ADDENDUM NO. 3

RFP #22-53

Valve and Finished Water Tank & Reservoir Improvements

The following changes, additions, and/or deletions shall be made to the Request for Proposal (RFP) for Water Treatment Service Unit – Valve and Finished Water Tank & Reservoir Improvements, RFP #22-53.

SINGLE SECONDARY ACCESS HATCH PLAN
WATER TREATMENT RESERVOIR
SCALE: 1/2" = 1'-0"
NORTH

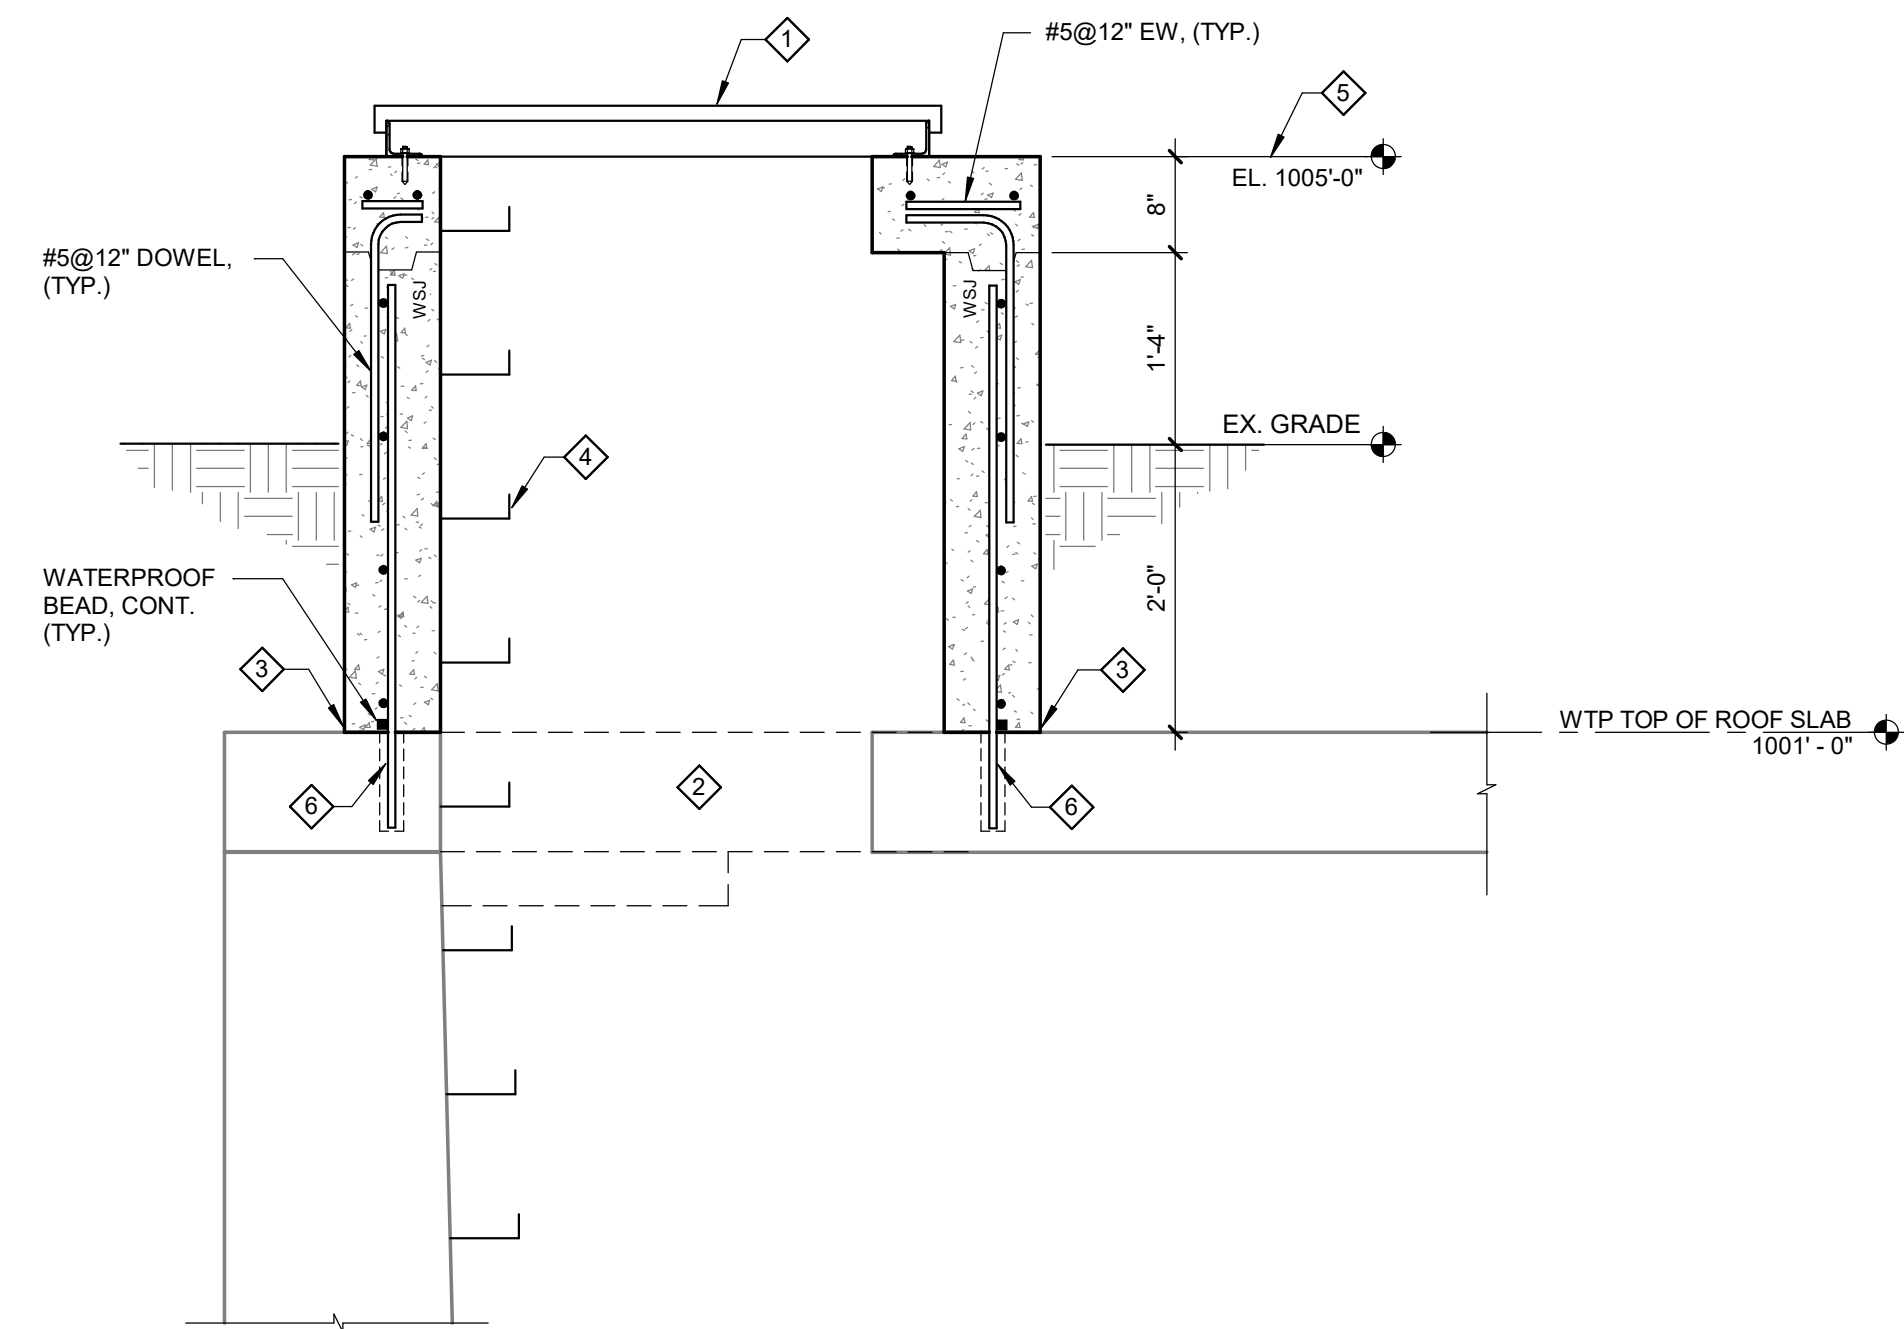
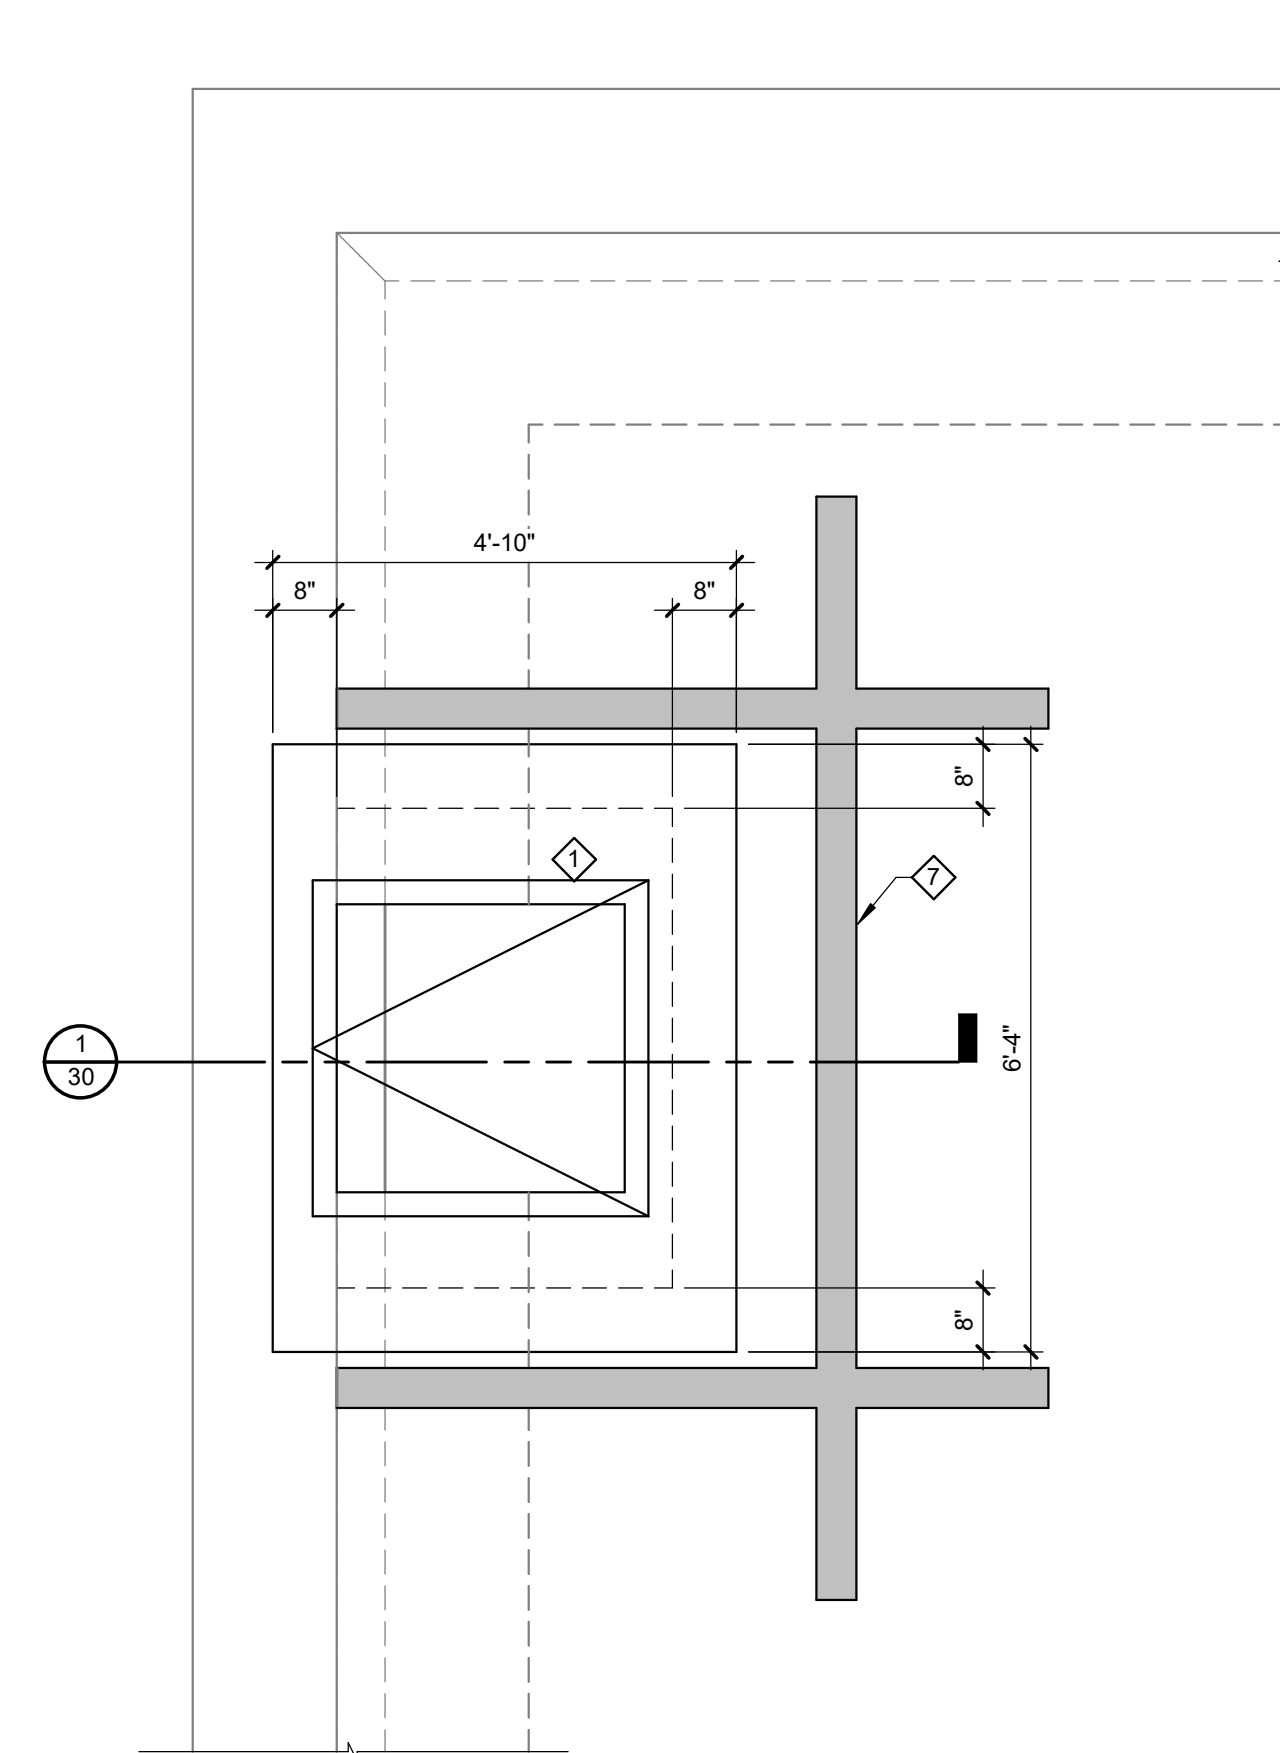
CC. Alternate #8 – Install New Reservoir Access Hatches:

1. Includes the following in accordance with Division 03 Section “Cast-in-Place Concrete,” Division 08 Section “Access Hatches,” and Division III “Materials Standards” of the City of Ann Arbor Standard Specifications.
 - a. Installation of three new access hatches on the existing reservoir roof slab.
 - b. All materials, equipment and labor for excavation, temporary interior protection and backfill of the structure.
 - c. Removal and disposal of existing manhole frames and covers and concrete curb as needed for replacement.
 - d. Carbon fiber reinforcement and sawcutting of new roof slab opening.
 - e. Furnish and install new cast-in-place structural concrete curb sections and with integral access hatch.
 - f. Furnish and install new ladder rungs into reservoir.
2. Unit of Measure: Lump Sum.

- H. Alternate #8:
 - 1. **Install New Reservoir Access Hatches:**
 - a. Base Bid #1 does not include a pay item for Install New Reservoir Access Hatches as indicated on Sheets 16 and 30.
 - b. Add Item “Alternate #8 – Install New Reservoir Access Hatches” to Base Bid #5 as specified in Division 01 Section “Unit Prices – Measurement and Payment” and as indicated on Sheets 16 and 30.

- 42" SQUARE SURFACE MOUNTED ACCESS HATCH CENTERED OVER 36" SQUARE OPENING IN NEW SLAB, POSITIONED OVER NEW SAWCUT OPENING IN EXISTING SLAB.
- SAWCUT NEW 24" WIDE (NORTH/SOUTH) x 36" LONG ACCESS HOLE IN RESERVOIR TOP SLAB.

- ANCHOR BAR 8" INTO EXISTING SLAB WITH HILTI HY-200 SAFE SET.
- PROVIDE CARBON FIBER REINFORCING PLASTIC (CFRP) ON TOP OF TOP SLAB OF RESERVOIR, EACH SIDE OF NEW ACCESS HOLES, EACH DESIGNED TO OFFSET THE CUTTING OF 2.17 SQ. IN. OF GRADE 33 REINFORCING TOP BARS. LAP CFRP PAST HOLES AS REQUIRED TO DEVELOP FULL STRENGTH OF CFRP. WRAP CFRP OVER EDGE OF SLAB AS NECESSARY FOR DEVELOPMENT.

- THE INFORMATION OF THIS SHEET APPLIES TO EACH OF 3 NEW HATCHES FOR THE WATER TREATMENT PLANT RESERVOIR; SEE THE SITE PLAN ON SHEET 16 FOR LOCATIONS.
- THE INFORMATION ON THIS SHEET IS PART OF ALTERNATE NO. 8.
